Point Beach Nuclear Plant, Units 1 and 2
Dockets 50-266 and 50-301
Renewed License Nos. DPR-24 and DPR-27

Response to Request for Additional Information
License Amendment Request 247
Spent Fuel Pool Storage Criticality Control

**ADDENDUM TO WCAP-16541 REVISION 2
POINT BEACH UNITS 1 AND 2
SPENT FUEL POOL CRITICALITY SAFETY ANALYSIS**

**Point Beach Units 1 and 2
Spent Fuel Pool Criticality
Safety Analysis - Addendum**

Figure 4-1 Fuel Assembly Burnup versus Initial Enrichment for the “All-Cell” Storage Configuration

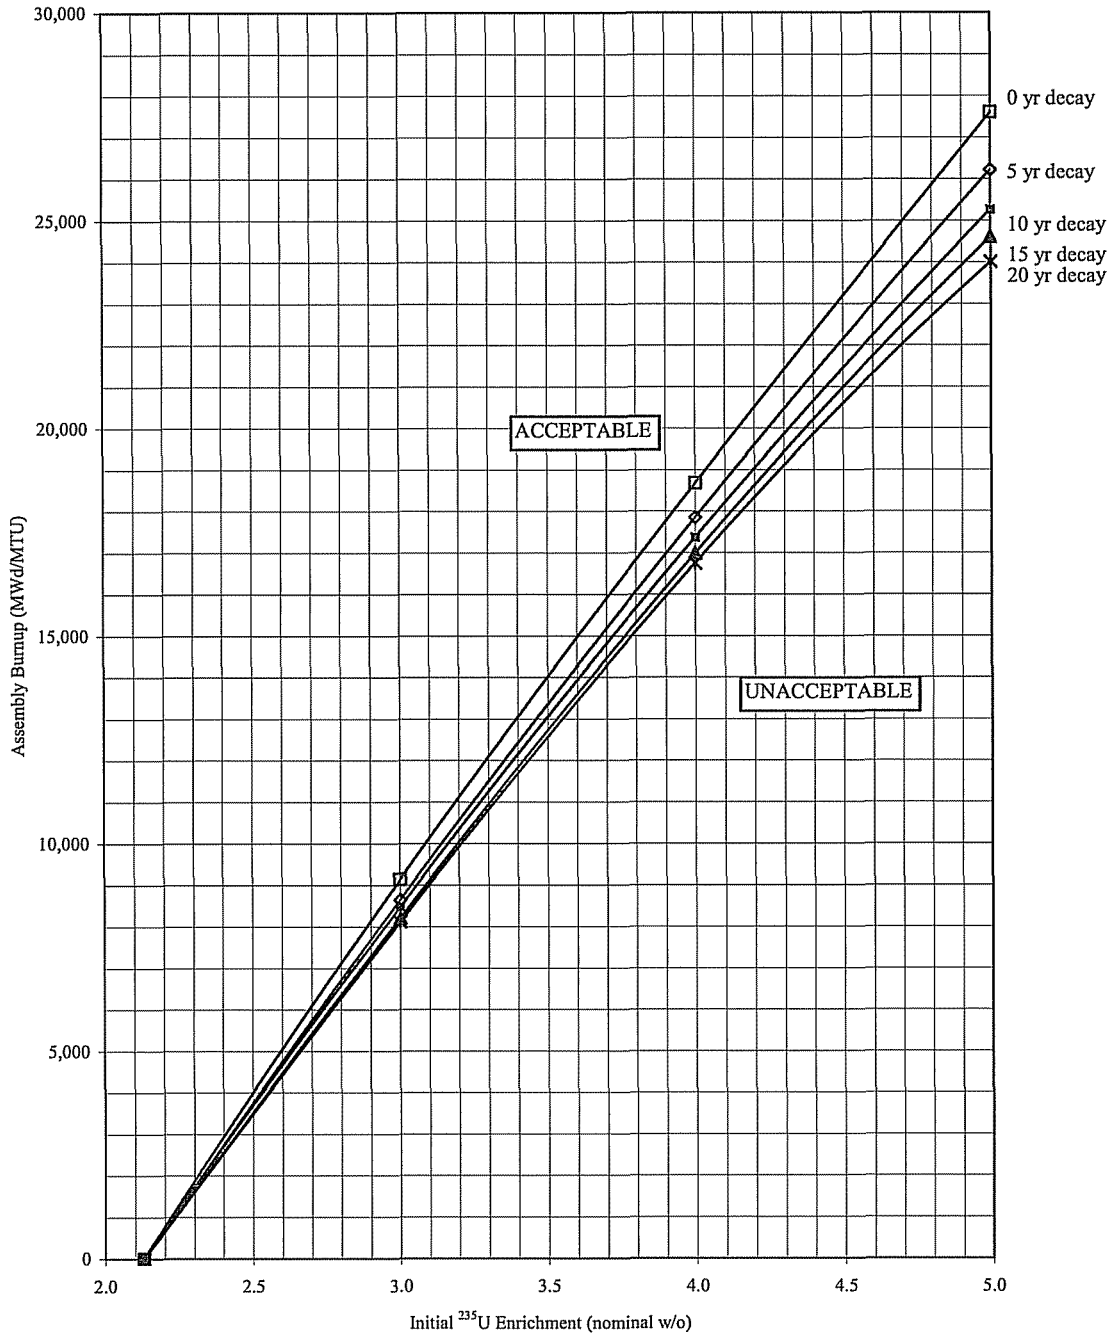
Based on the information submitted by the licensee to date, the staff finds that the licensee's analysis does not provide reasonable assurance that Point Beach fuel storage will comply with the regulatory limit of k_{eff} less than 1.0 under unborated conditions. Currently, there is not a generically approved methodology for performing an SFP criticality analysis. Therefore, licensees must submit a plant-specific SFP criticality analysis that includes technically-supported margins. Issues identified during staff review to date have reduced the reserved analytical margin, an order of magnitude from 0.5% Δk to 0.049% Δk . The analysis currently shows a maximum k_{eff} of 0.99951. The analytical margin is normally reserved to address potential uncertainties that are unaccounted for. The reserved analytical margin of 0.049% Δk essentially requires that there are no other uncertainties that must be accounted for, and that the remaining portions of the analysis are without issues. The staff finds that this is not the case for the Point Beach analysis.

less than 1.0 under unborated conditions. For the staff to continue its review, the licensee should consider resubmitting an analysis that restores the full 0.5% Δk analytical margin for the proposed storage configurations, incorporating any identified non-conservatisms. Alternatively, the licensee may attempt to regain the analytical margin by identifying and quantifying the conservatisms in their analysis. However, this approach usually results in a more lengthy review with additional RAIs to substantiate the identified conservatisms."

The minimum administrative margin gain for the "All-Cell" configuration, shown in Table 3-2, is 0.00138 Δk . From Table 2-1, the additional margin needed to return the administrative margin to 0.005 Δk is 0.00131 Δk . The burnup offsets shown in Table 3-2 will return all initial enrichment/decay time combinations in the "All-Cell" configuration to greater than 0.005 Δk administrative margin. Table 4-3 and Figure 4-1 present the updated burnup limits for the "All-Cell" configuration.
